SUBJECT: AUDIT OF ACTIONS RELATING TO NRC BULLETIN 38-09, "THIMBLE
TUBE THINNING IN WESTINGHOUSE REACTORS," FOR JOSEPH M. FARLEY
NUCLEAR PLANT, UNITS 1 AND 2, (TAC NOS. 72659 AND 72660)

AUDIT TRIP REPORT

PURPOSE: Audit of Joseph M. Farley Units 1 & 2 on Bulletin 88-09 Issues (BMI Thimble Tube Wear)

Seal Table Photographs

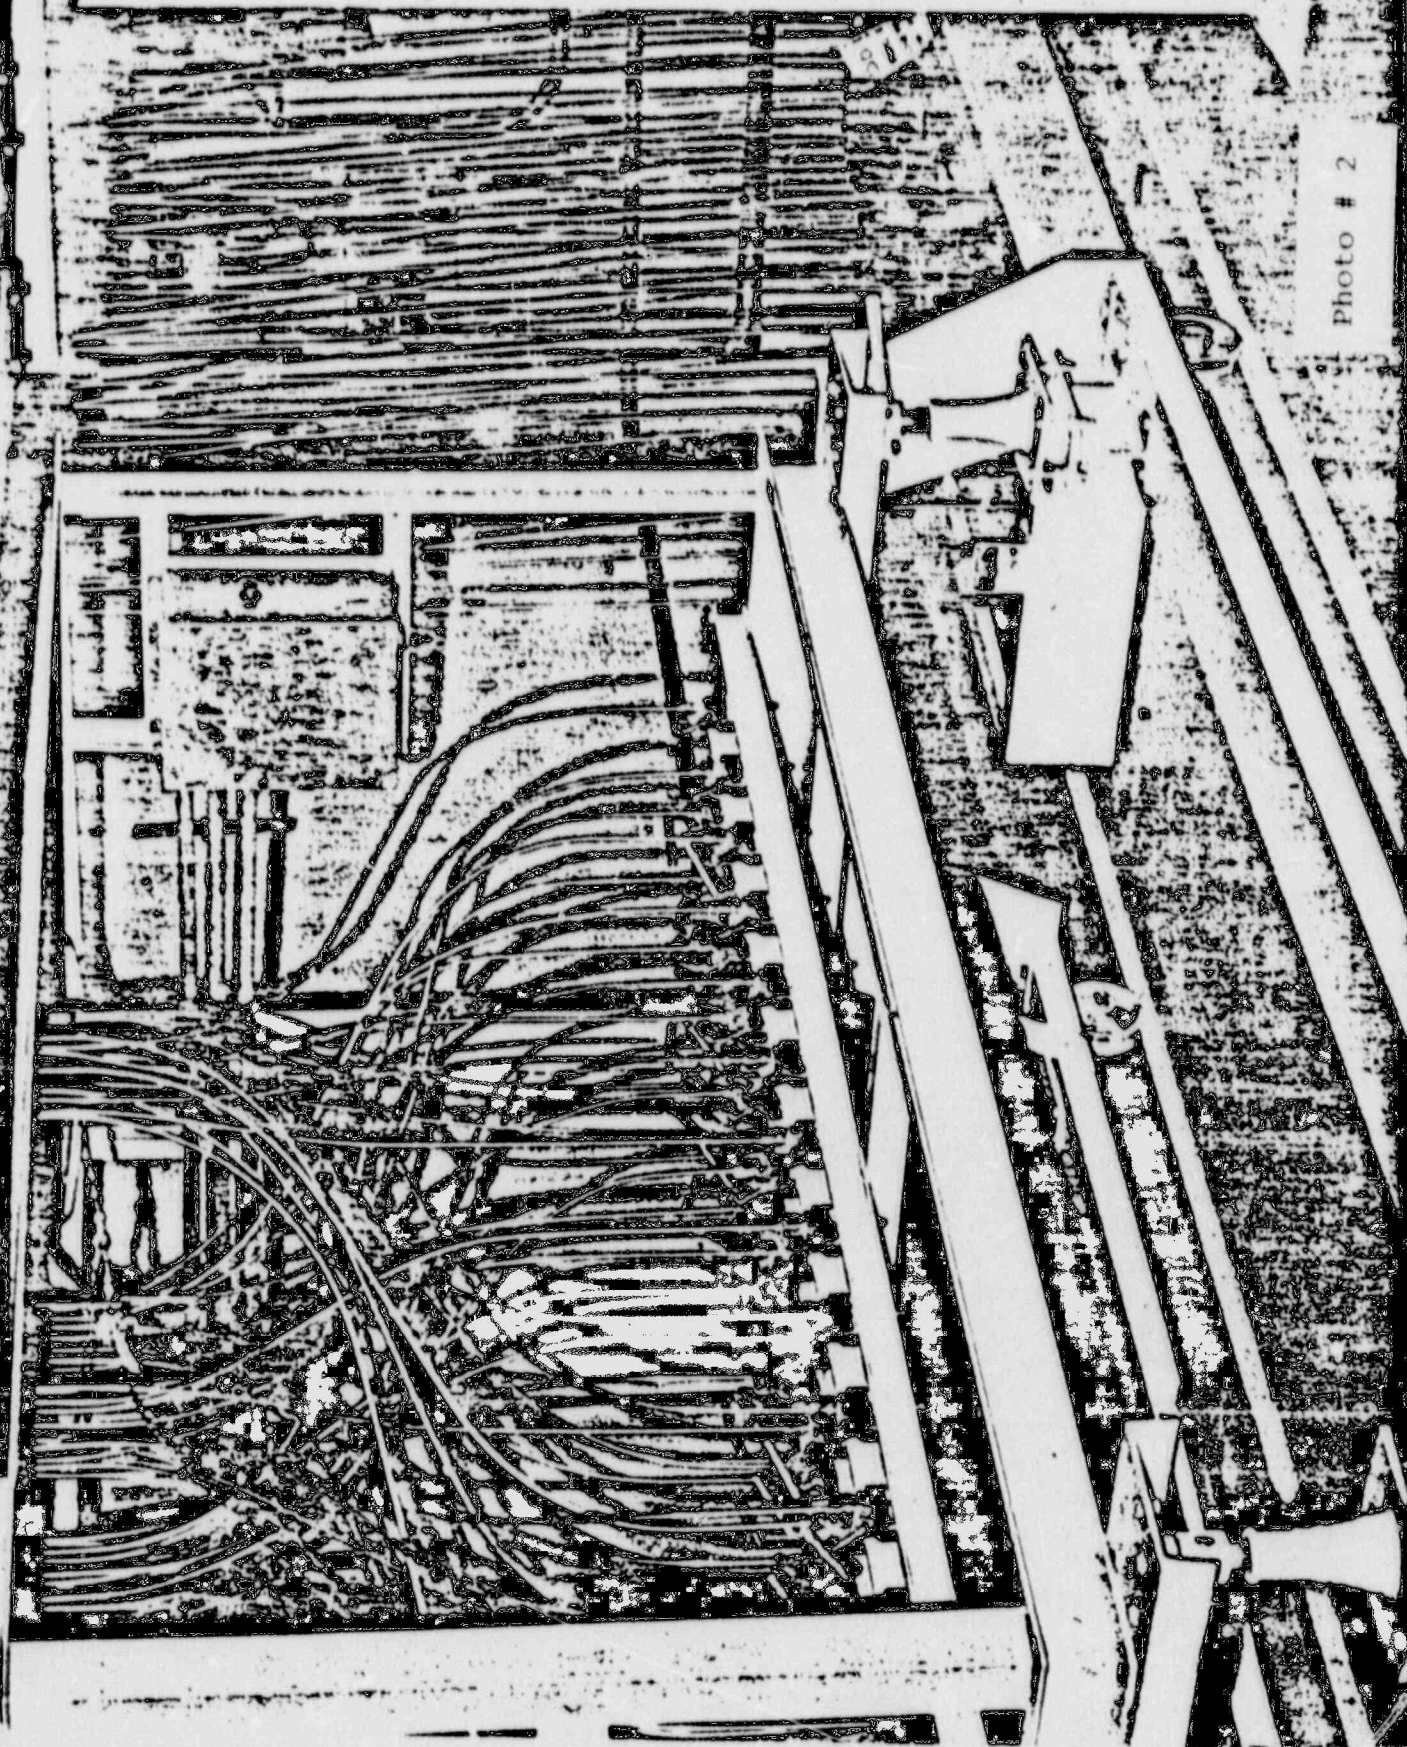
It is not clear how the bottom portion of the BMI transfer cart, which contains the track wheels for rolling the transfer cart away from the seal table, is restrained from rolling or against seismic excitation after the upper portion of the transfer cart is bolted down to its front and back anchor post.

The upper and bottom portions of the BMI transfer cart are never separated from each other. The 4 bottle jacks that raise and lower the upper portion relative to the bottom portion are permanently fixed at the top with 4 bolts each to the top portion and at the bottom with 4 bolts each to the bottom portion of the transfer cart. Once the upper portion is bolted to its anchor posts above the seal table the entire transfer cart is restrained from moving in a seismic event.

From MECHANICAL EQUIPMENT DESIGN
WIN 236-6366
Date November 27, 1989
Subject Evaluation of Echoram Wear Scar

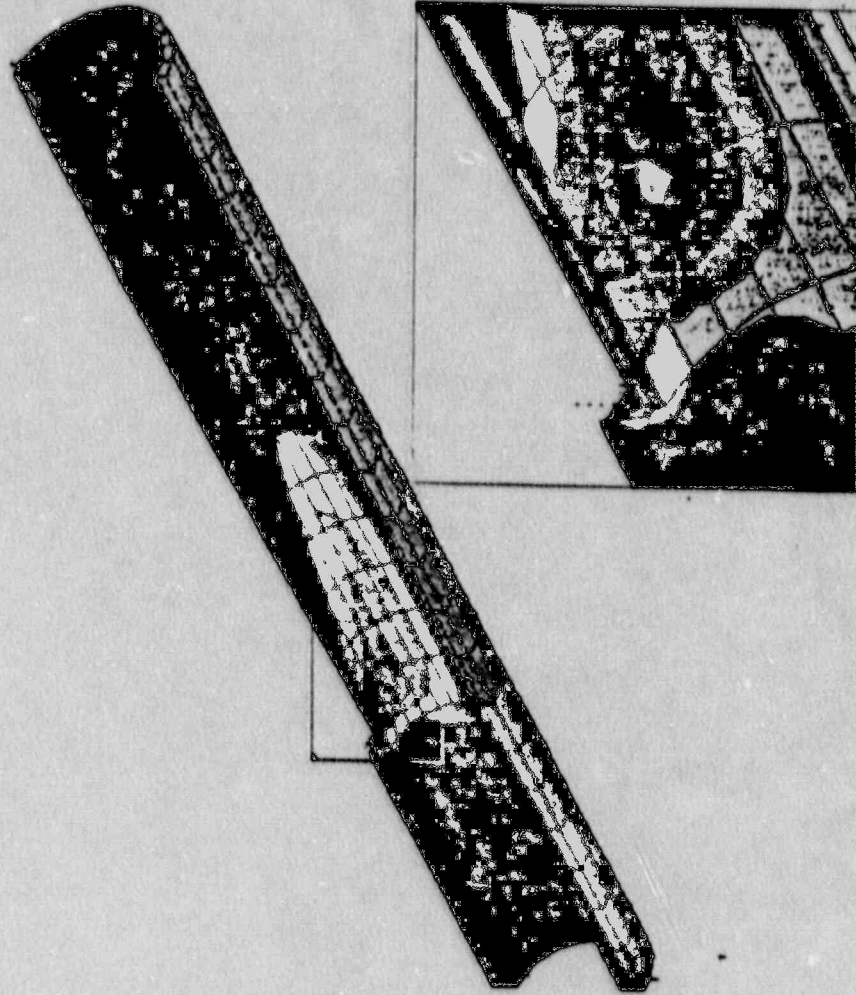
The wear scar geometry described in the Westinghouse finite element analysis report, RPVSA-89-1351, to justify the 65 percent allowable wall loss criteria is different from that described for the wear scar calibration standard in the Echoram ECT Report.

The wear scar geometries in the two reports are different. The geometry used by Westinghouse in the finite element analysis was judged to be conservative for predicting maximum stress values for given wear scar depths. The geometry used by Echoram as a calibration standard for measuring wear is considered to be a more representative approximation of actual scars and would be more conservative, for estimating wear depth for a given volume of material removed, than that defined by the finite element analysis model. ECT inspections determine wall loss by measuring the volume of material removed.

A new finite element analysis has been performed by Westinghouse, modeling the geometry of the Echoram calibration standard. The results of this new analysis shows that the predicted stress values for 65 percent wall loss are less than originally predicted. This confirms the original analysis assumption that the scar geometry was conservative.

This analysis was based on wear scars identified in Echoram drawing WS-A-007-89, and can be described as a 90° wear scar, with 65% wall loss, and a length of 0.97 inches.
